service bulletin

M90-17
 Supersedes M83-10R.1
 and M77-14R.1
 Technical Portions Are
 FAA Approved

SUBJECT: **CRANKCASE INSPECTION CRITERIA**

MODELS
 AFFECTED: All

FIGURE 2 O-200 CASE

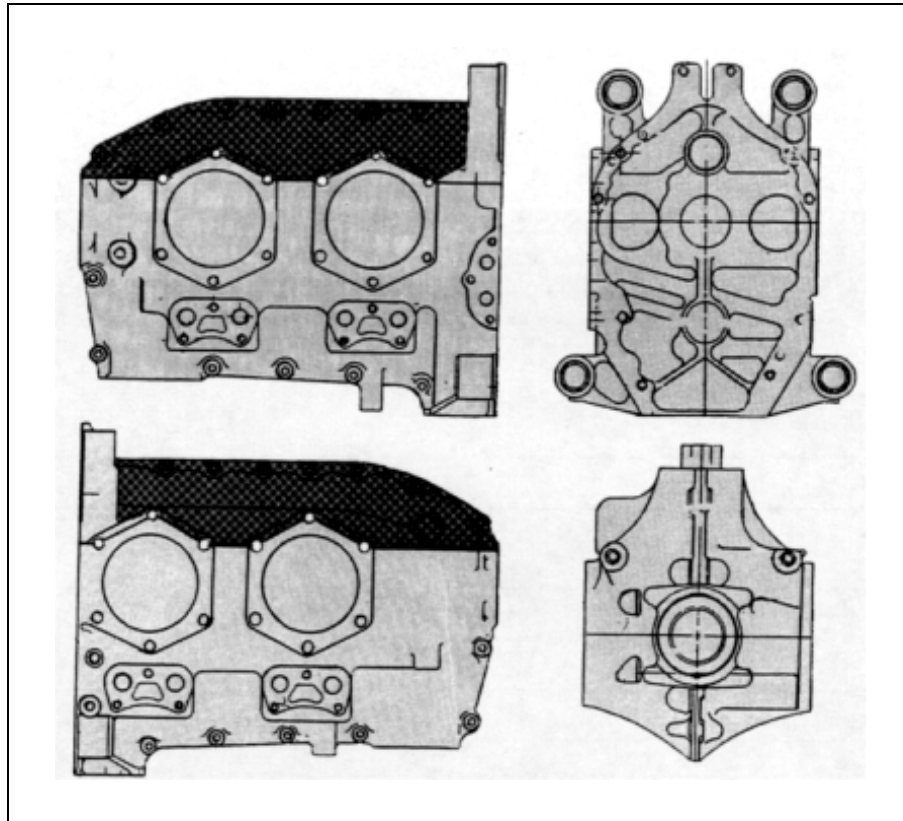
Critical (gray) and non-critical (dark gray) areas are illustrated in Figures 2,3,4,5,6 & 7. If a crack is observed in any of the non-critical (dark gray) areas less than two (2) inches in length, the crack should be scribe marked at its extremities and re-inspected for crack progression at the next 50 hours of operation, see Figure 1. If no crack progression is observed and no additional cracks are found, continue to re-inspect at regular intervals not to exceed 100 hours duration.

If a crack is observed in any of the non-critical (dark gray) areas more than two (2) inches in length or if a previously observed crack has progressed to two (2) or more inches in length, repair or replace the crankcase or engine prior to further flight. If any crack is observed in a critical (gray) area, repair or replace the crankcase or engine prior to further flight.

- A. Any crack in the critical (gray) area.
- B. Any crack two (2) inches or more in length in the non-critical (dark gray) area.
- C. Any size crack that is leaking oil (not seeping).
- D. Major overhaul with crankcases having lower numbers than set forth in Table 1.
